<b>Subject:</b>  NOISE FROM FUEL TANK INSULATOR	<b>Bulletin No:</b> 01-010/15
	<b>Last Issued:</b> 12/14/2015

- This bulletin supersedes the previous bulletin 01-010/15, issued on 05/26/15. The APPLICABLE MODEL(S)/VINS and PART(S) INFORMATION has been revised.
- Changes are noted below in Red beside the change bar.

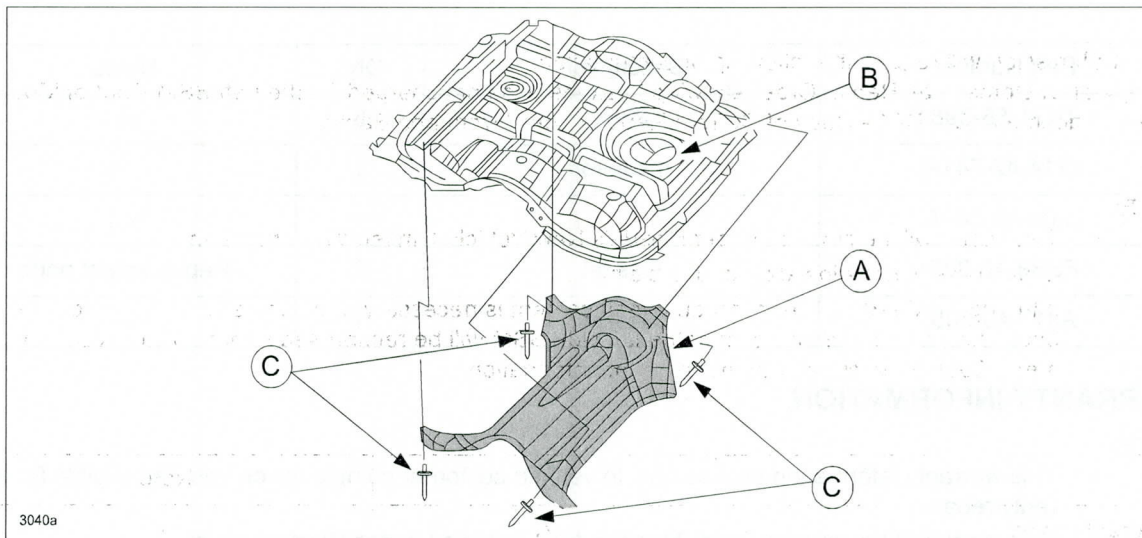
Some vehicles may exhibit an unusual noise while driving the vehicle. The noise may be caused by a broken fuel tank (B) insulator (A) that is hanging down and contacting the propeller shaft.

The rivets (C) may break when a load occurs. The rivet material has been changed to eliminate this concern. Customers having this concern should have their vehicle repaired using the following repair procedure.
